# Access Compliance Report

## Public Rights-of-Way

### (Curb Ramps)

Intersection ID: 11926	Main Street: WILKINSON_BV	Cross Street: BOYER_ST	Location: SE
ADA ID: BFE30364BC67	Ramp Type: Perp	Initial Pass/Fail: Fail	Overall Compliance: No
Codes/Mitigation Info/Possible Solution			Severity Score: 10
			Field Measurements/Component Compliance

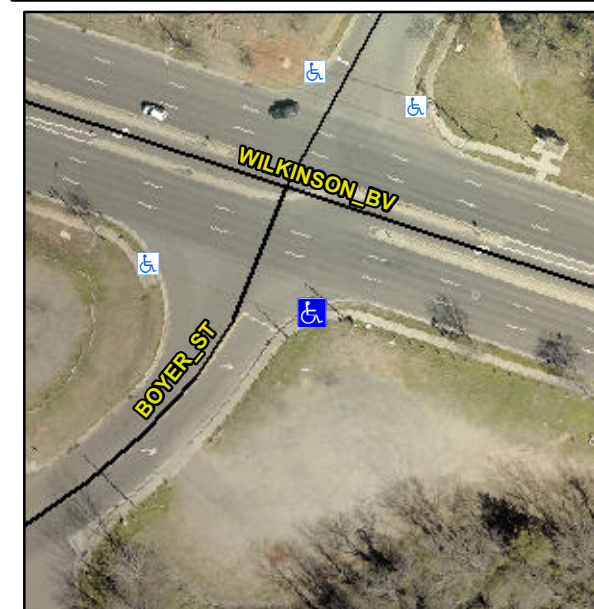
**R304.5.1, R304.5.3**

Compliance	Description	Data	Compliance	Description	Data
N/A	Ramp Length (in)	73.0	Yes	Ramp Slope (%)	8.0
No	Ramp Width (in)	44.0	No	Ramp XSlope (%)	3.2
N/A	Flare Type LT	N/A	N/A	Flare Type RT	N/A
N/A	Flare Slope LT (%)	N/A	N/A	Flare Slope RT (%)	N/A
N/A	Flare Traversable LT?	N/A	N/A	Flare Traversable RT?	N/A
N/A	Landing Length (in)	N/A	N/A	DWS Provided?	N/A
N/A	Landing Width (in)	N/A	N/A	DWS Contrast?	N/A
N/A	Landing Slope (%)	N/A	N/A	DWS Length (in)	N/A
N/A	Landing X Slope (%)	N/A	N/A	DWS Full Width?	N/A
N/A	Landing Curb? (Y/N)	N/A	N/A	DWS Offset (in)	N/A
N/A	Shared Landing?	N/A			
N/A	Gutter Ponding?	N/A	N/A	Gutter Slope (%)	N/A
N/A	Gutter Lip Ht (in)	N/A	N/A	Gutter X Slope (%)	N/A
N/A	Painted X Walk1?	No	N/A	Painted X Walk2?	N/A
	X Walk 1 Direction	To NW		X Walk 2 Direction	N/A
N/A	X Walk 1 Width (in)	N/A	N/A	X Walk 2 Width (in)	N/A
	X Walk 1 Slope (%)	1.0		X Walk 2 Slope (%)	N/A
	X Walk 1 X Slope (%)	2.8		X Walk 2 X Slope (%)	N/A

N/A	Ramp inside XWalk1?	N/A	N/A	Ramp inside XWalk2?	N/A
	Road Slope (%)	N/A	N/A	Clear Space?	N/A
	Road X Slope (%)	N/A	N/A	Clear Space to XWalk (in)	N/A
N/A	Any Obstructions?	N/A	N/A	Storm Grate/Utility Hazard?	N/A
	Obstruction Type			Storm Grate/Utility Type	
		N/A			N/A
			Yes	Surface Condition? (G/P)	Good

**Remove & Replace Entire Ramp.**
